Loreto Normanhurst Redevelopment (Concept Proposal and Stage 1)

State Significant Development Assessment
SSD 8996

August 2021

Title: Loreto Normanhurst Redevelopment (Concept and Stage 1)

Figure 28 | Comparison between the original EIS (top) and revised RtS (bottom) Concept Proposal envelopes and layouts indicating the key changes (Base source: Applicant's EIS 2019 and RtS 2021)

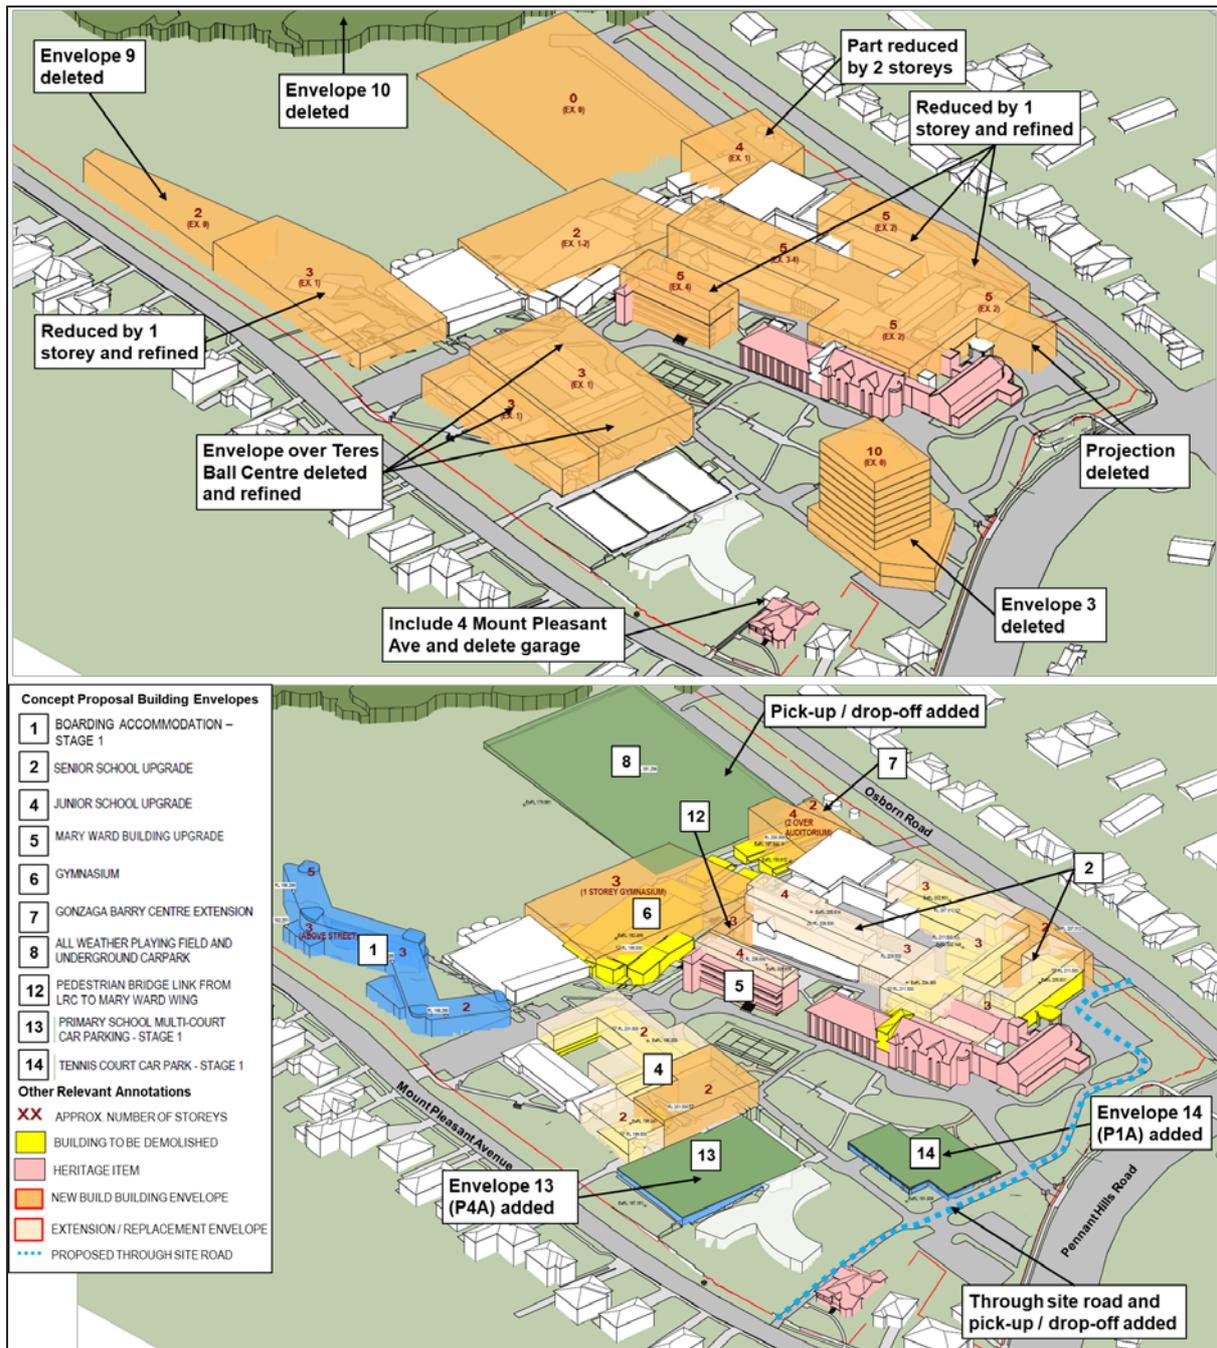
5.4.2 On 15 February 2021, the Applicant submitted its RtS (**Appendix A**). The RtS provides additional information and clarification in response to the issues raised in submissions. The RtS also included the following key amendments to the proposal (**Figure 28**):

Figure 29 | Existing and proposed Stage 1 pick-up/drop-off facilities and queue lengths
(Base source: Applicant's SRtS)

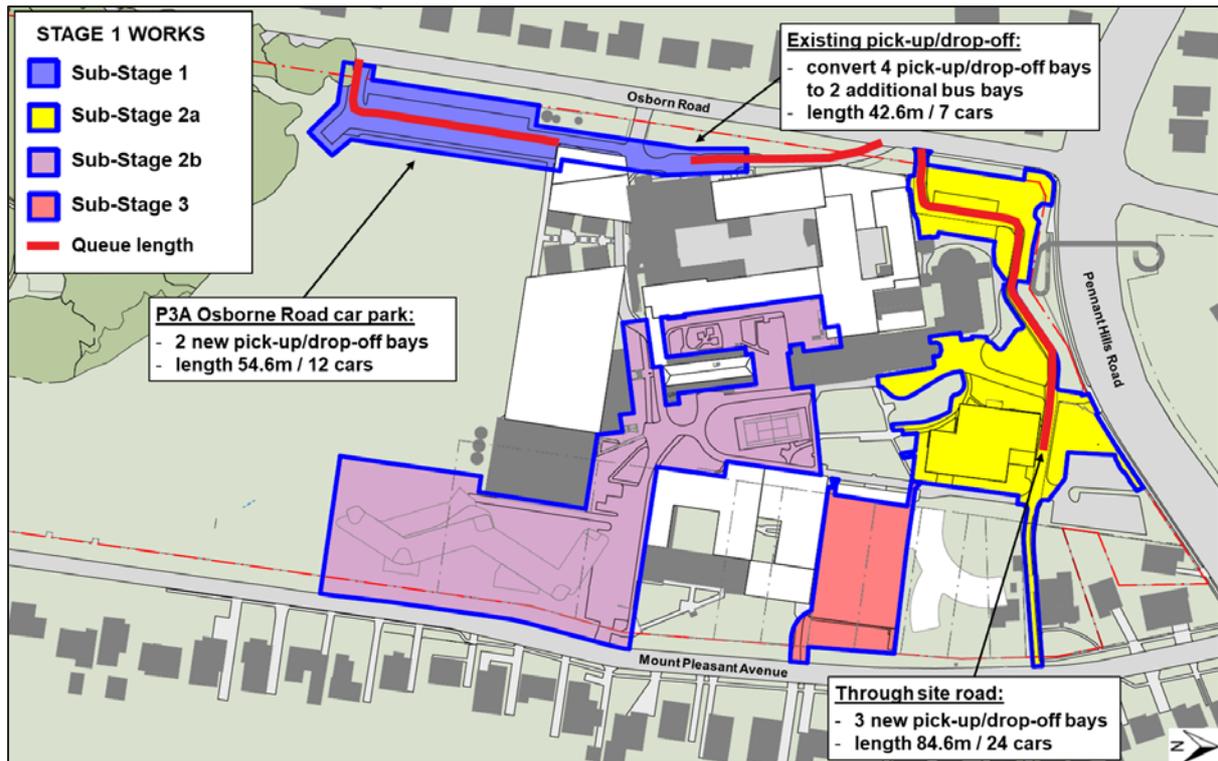
- 6.2.37 In response to the concerns raised by Council and Bitzios, the Applicant's SRtS provided detail of queue lengths for all stages of the Concept Proposal (**Figure 29**) and confirmed the pick-up/drop-off facilities have been designed to include through-lanes that enable vehicles to pass and recirculate

Figure 31 | The TAR temporary through site road originally proposed by the RtS (left) and updated construction site and access arrangements proposed by the SRtS (right) (Base source: Applicant's RtS and SRtS)

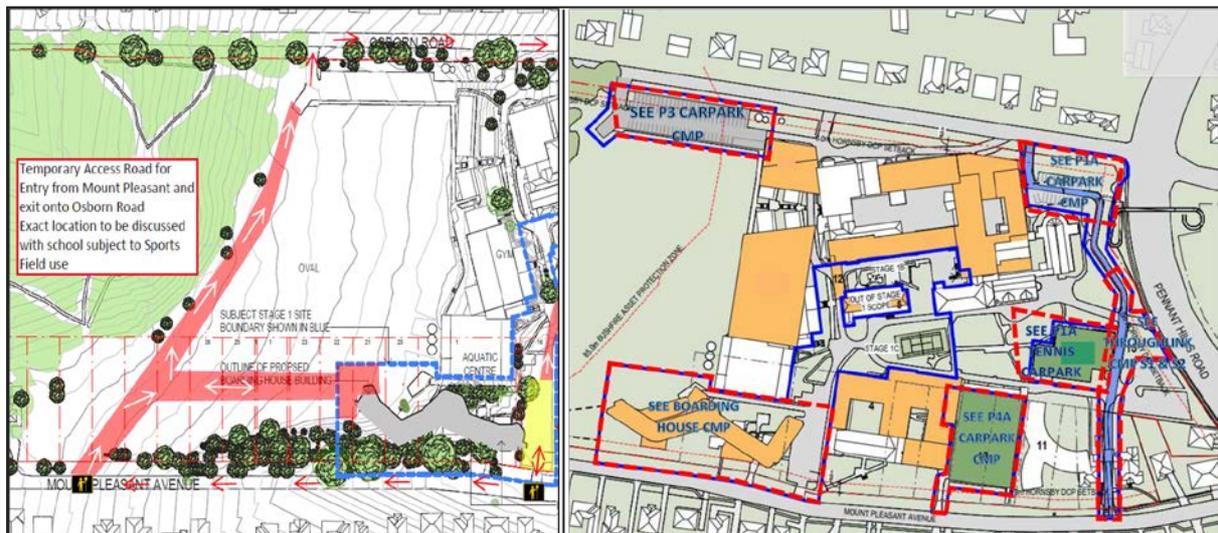
6.2.135 The TAR originally proposed a temporary road along the southern boundary of the oval allowing construction vehicles to cross the site and exit onto Osborn Road via the existing P4 Osborn Road carpark. However, the amended proposal does not confirm this arrangement (**Figure 31**).

Figure 36 | Massing of Envelope 2 looking south-west (Base source: Applicant's RtS)

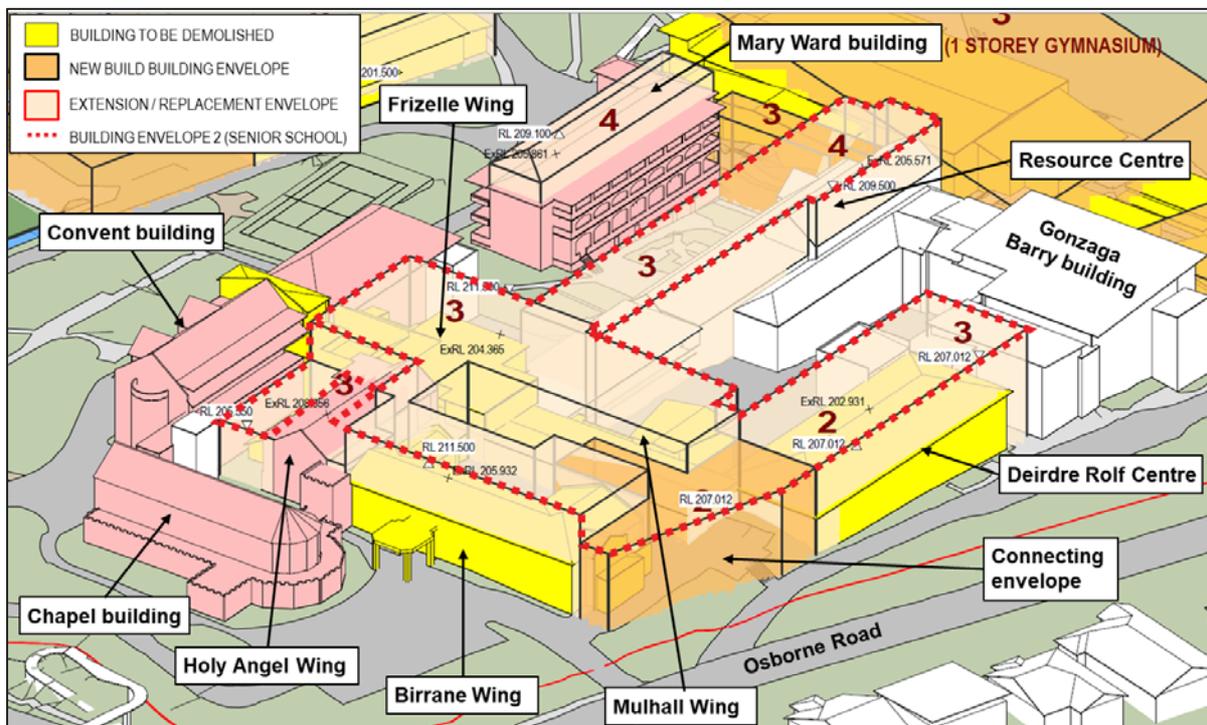
6.3.19 Building envelope 2 (senior school) comprises (**Figure 36**):

Figure 37 | Existing view of the Birrane Wing and Deirdre Rolf Centre from Osborn Road (top), Applicant's massing perspective from Osborn Road (bottom) (Base source: Applicant's RtS)

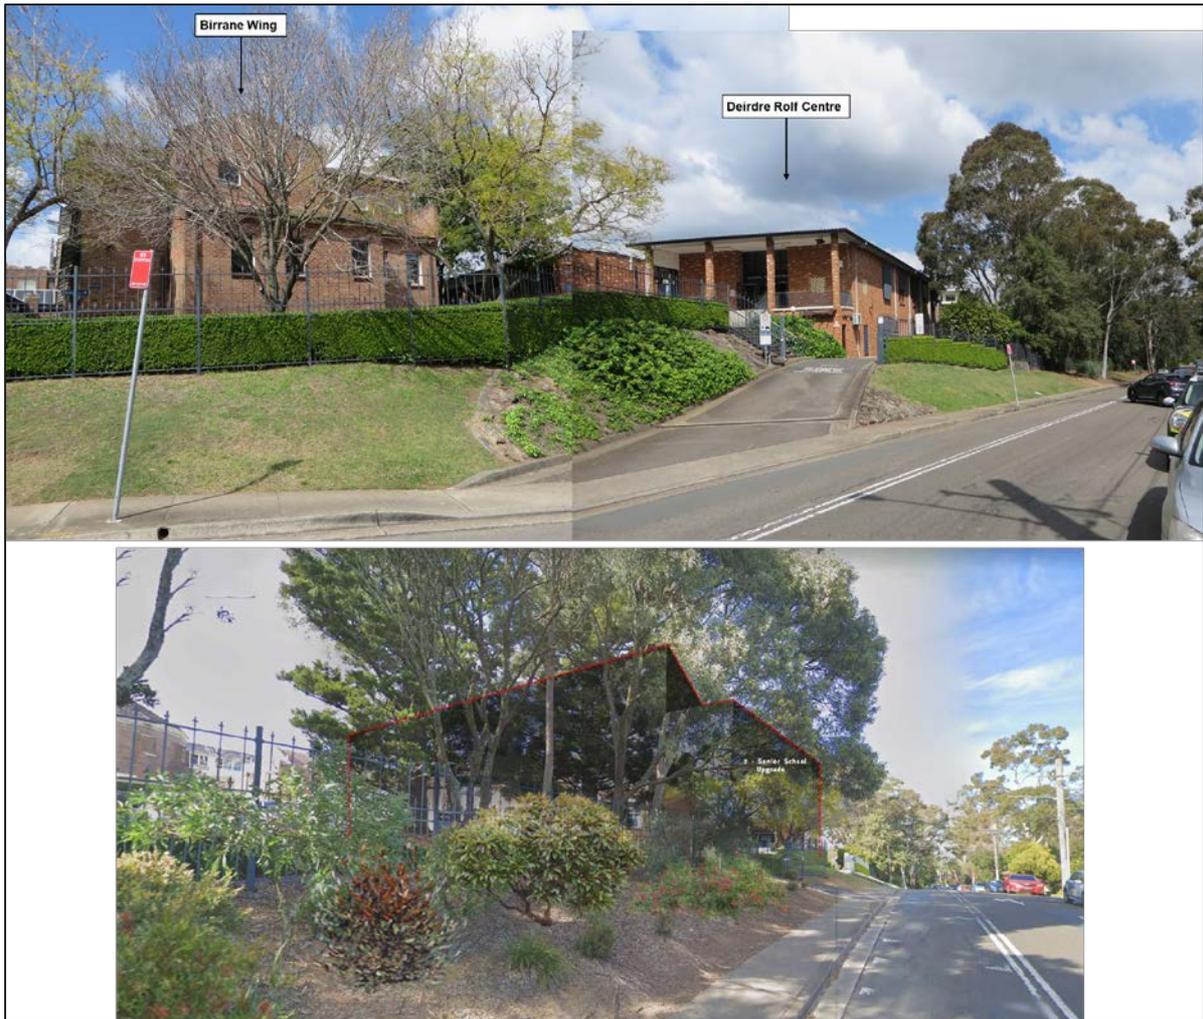
6.3.23 Notwithstanding these changes, the Department maintains its concern that the Birrane Wing, Deirdre Rolf Centre and connecting envelope that form part of Envelope 2 have the potential to facilitate future development that would present significant height, bulk and scale when viewed from Osborn Road as evident in **Figure 35**. This is because:

Figure 44 | Proposed ground floor plan showing location of the loading dock area and new driveways (Base source: Applicant's RtS)

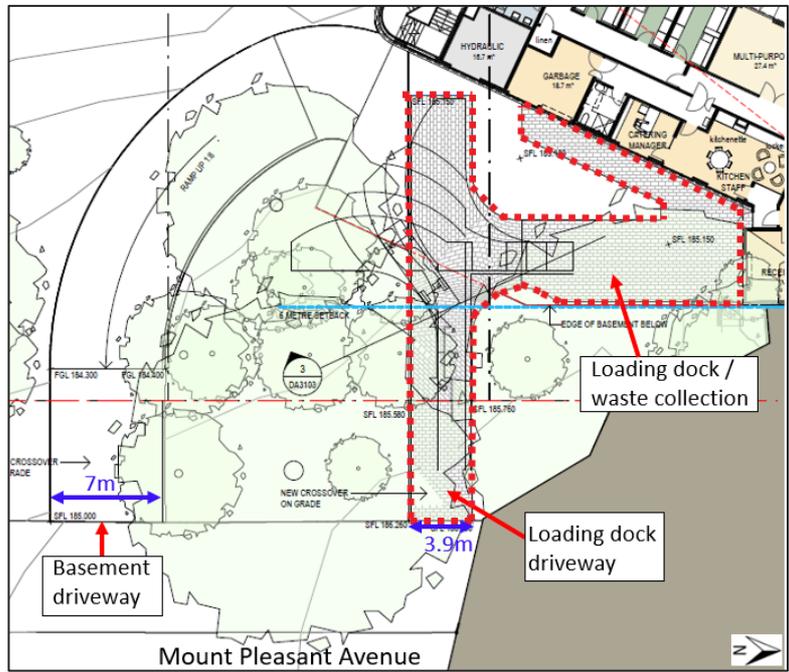
- 6.4.19 Notwithstanding the above, the Department has identified nine additional trees (including three of high retention value) that could be retained subject to minor design amendments to the Boarding Accommodation building ground level and basement layout. The proposed building contains an at-grade loading dock (for deliveries and waste collection), associated turning circle area and separate driveway only to service the loading dock (**Figure 44**) requiring the removal of nine trees identified in **Figure 45**.

6.4.22 The Department considers that the design of the basement could be amended to provide for all servicing, deliveries and waste collection to occur within the basement in order to avoid the unnecessary removal of trees and at least retain the nine subject trees (**Figure 46**).

Figure 45 | Landscape plan showing the proposed tree removal. The trees shaded yellow would be required to be removed to accommodate the loading dock area. (Base source: Applicant's RtS)

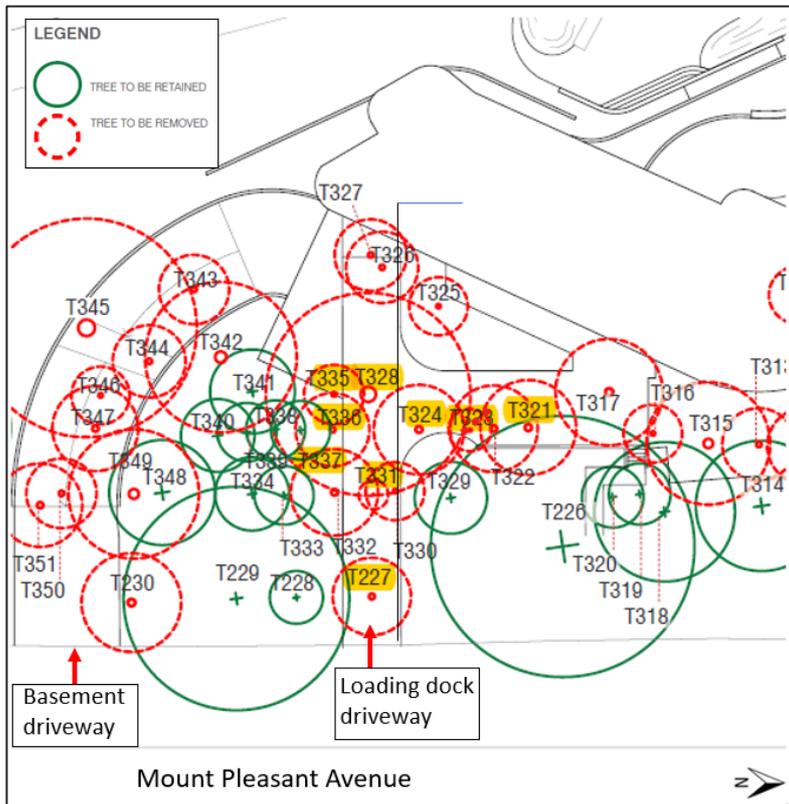
6.4.20 Approximately 15m south of the loading dock driveway is the proposed driveway to access the basement which requires the removal of thirteen trees (including two of high retention value). Consequently as a result of the two driveways and at-grade loading area, a total of 22 trees would require removal (**Figure 45**).
